NOTICE OF DATA INACCURACY

INSPECTION REPORT

Electrical Corporation:	Southern California Edison Company
Report Number:	PAD_SCE_SIS_20261007_0959
Date of Inspection:	October 7, 2026
City and/or County of Inspection:	Yucaipa, San Bernardino County
Inspector:	Samuel Isaiah
WMP Year Inspected:	2026
Quarterly Data Report (QDR) Referenced:	Quarter 2 (Q2)
Inspection Selection:	Energy Safety viewed the contents of the Q2 QDR and performed an analysis that resulted in the selection of the WMP initiatives and locations referenced in this report.
Relevant WMP Initiative(s):	8.2.1.1 – WCCP Covered Conductor
Inspection Purpose:	Assess the accuracy of Southern California Edison Company's QDR data, completeness of its work, and performance of WMP requirements.

Data Inaccuracy 1

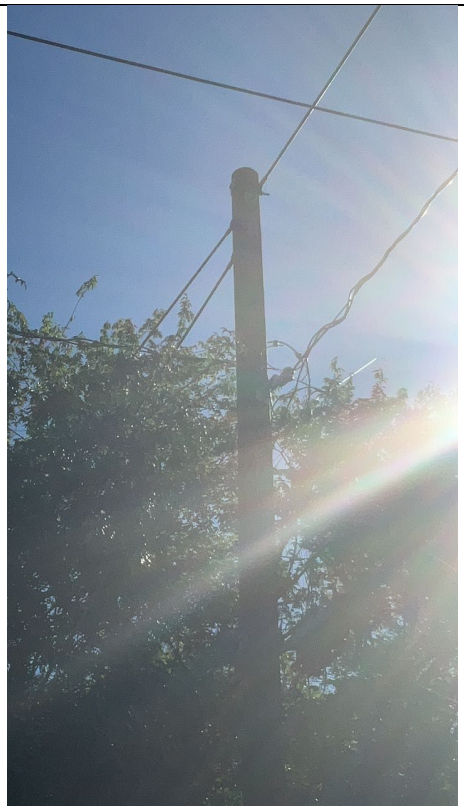
On Structure ID 4332414E, Grid Hardening ID TD2357977-4332414E at 35595 Avenue D, Yucaipa, CA, 92399, USA, coordinates 34.029614437502, -117.028147232709, the inspector observed that SCE failed to provide accurate data on covered conductor installation initiative. The inspector's observation is documented in Data Inaccuracy 1 photographs, which are attached to this report as Exhibit A.

1. SCE reported in the 2026 Q2 QDR that work on WMP initiative 8.2.1.1 – WCCP Covered Conductor was completed at this location.
2. In 2024, SCE informed Energy Safety that stub pole work does not count toward Covered Conductor WMP totals and would either identify or exclude these points in future QDRs. This data point did not contain an identifier and was not excluded.
3. No covered conductor was observed.

Asset Image 1: No covered conductor observed	**Asset Image 2**: No covered conductor observed

Within 30 days from the issuance date of this NODI, SCE should provide a response advising Energy Safety of corrective actions taken or planned to remedy the identified data inaccuracy or inaccuracies.
